CITY OF ALBUQUERQUE

RE: 715 Jaconita Place SW
Grading and Drainage Plan
Engineer's Stamp Date: 8/15/24
Hydrology File: L10D026A

Based upon the information provided in your submittal received 08/15/2024, the Grading & Drainage Plan is approved for Building Permit and Grading Permit. Please attach a copy of this approved plan in the construction sets for Building Permit processing along with a copy of this letter.

| | GRADING AND DRAINAGE PLAN | DATE 8-14-24 |

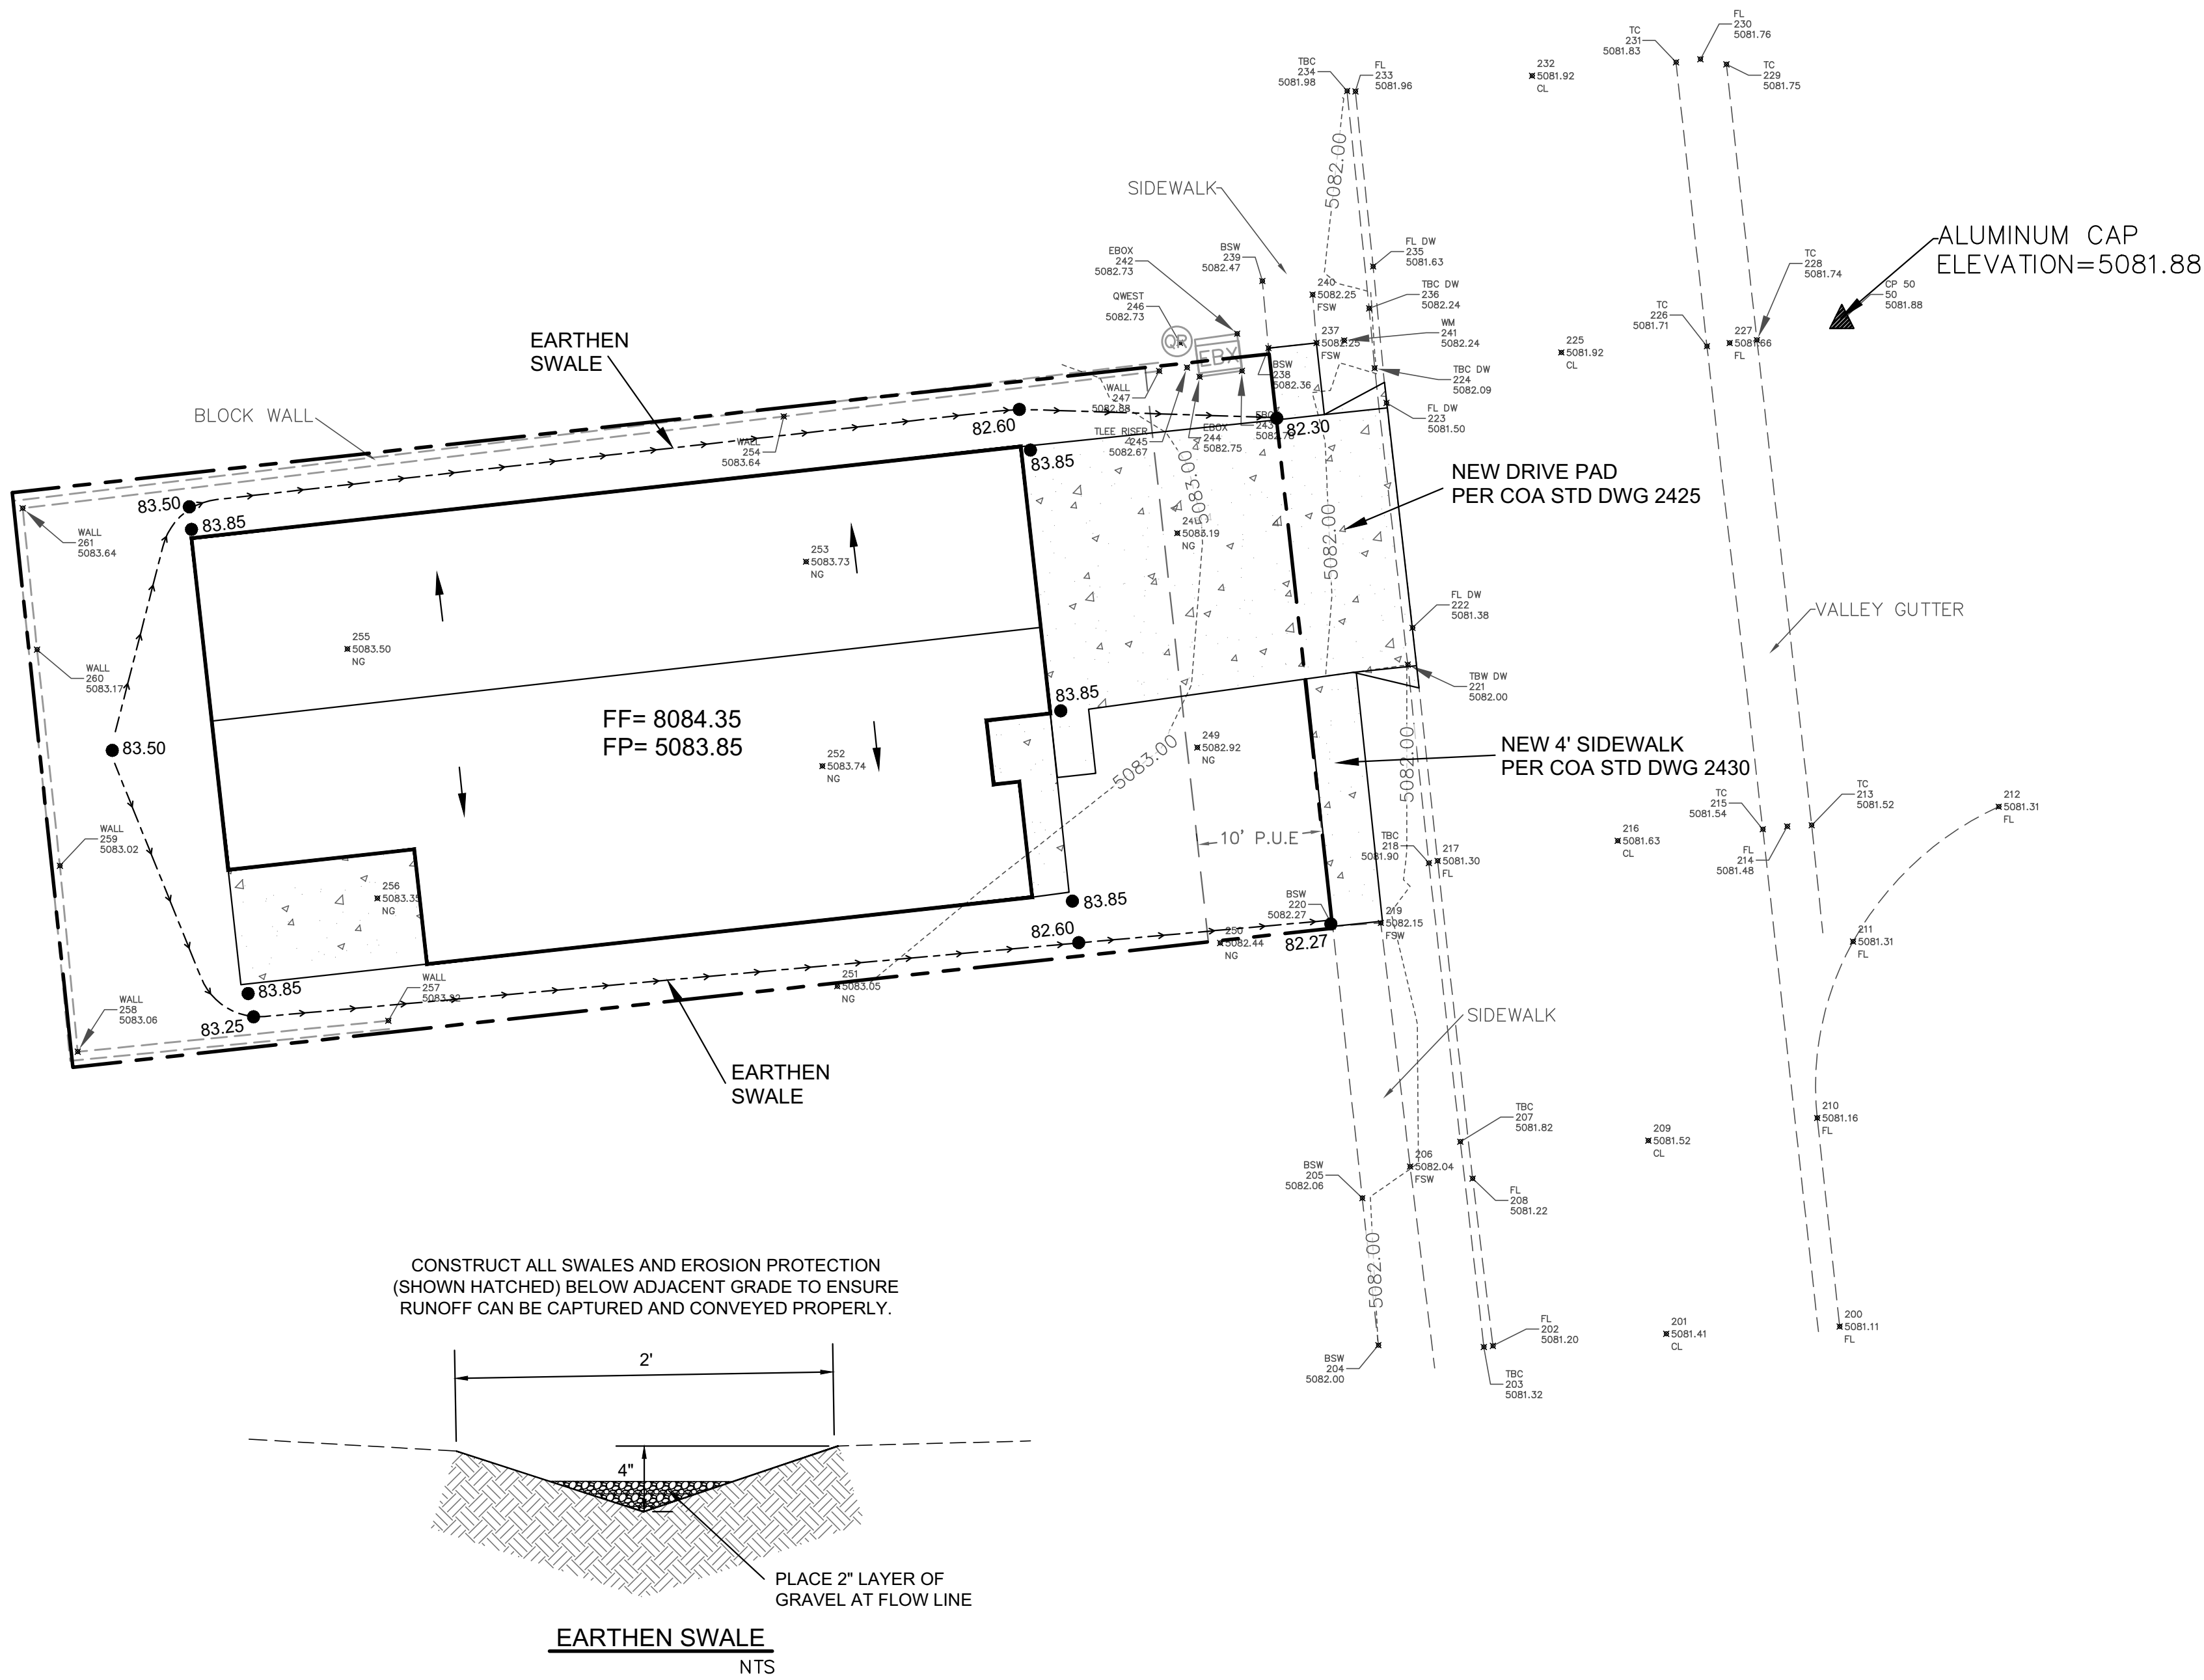
1. Engineer's Certification, per the DPM Part 6-14 (F): *Engineer's Certification Checklist For Non-Subdivision* is required.
